Product Safety Recall

N192278300 Front Seat Crossmember Improperly Welded

Release Date: February 2020

Revision: 01

5429380

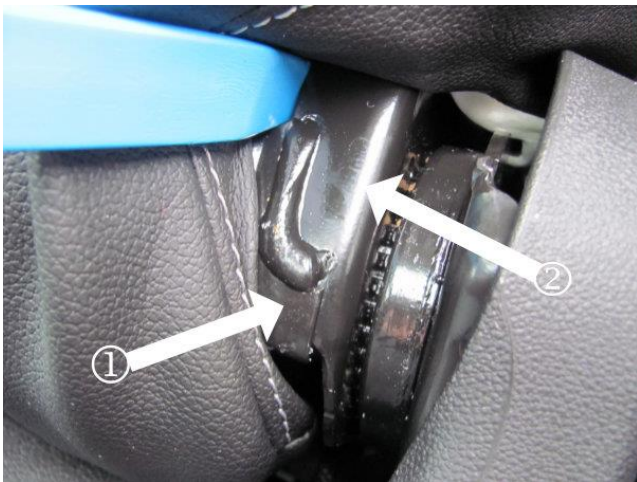
1. Fully recline the front driver side seat. Locate the two inspection areas.

5429381

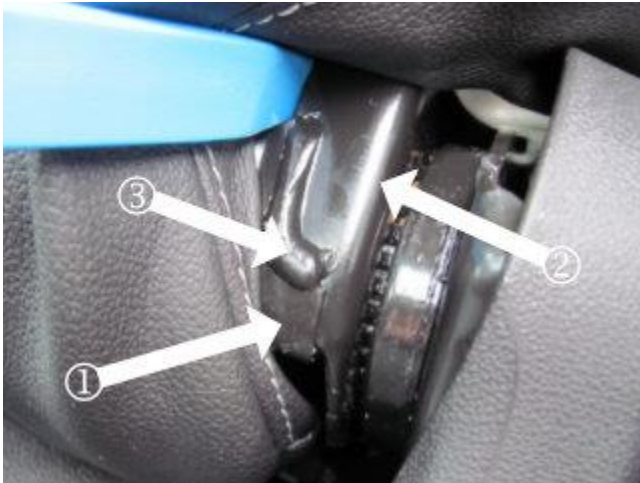
2. Using a trim stick, move the seat cover toward the center of the seat exposing the area where the lower seat cross bar (1) connects to the seat frame (2).

5429385

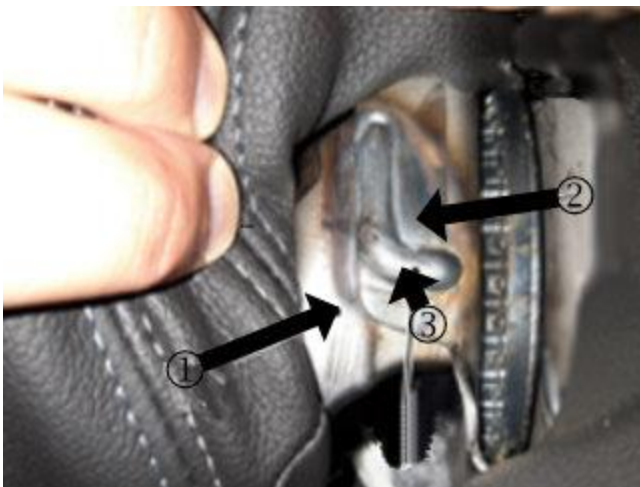
TIP: If the outboard edge of the seat cross bar is visible as shown, the seat is correctly assembled.

- If the lower seat cross bar (1) is on the outside of the seat frame (2) and the weld (3) is connecting the two components, no further action is required.
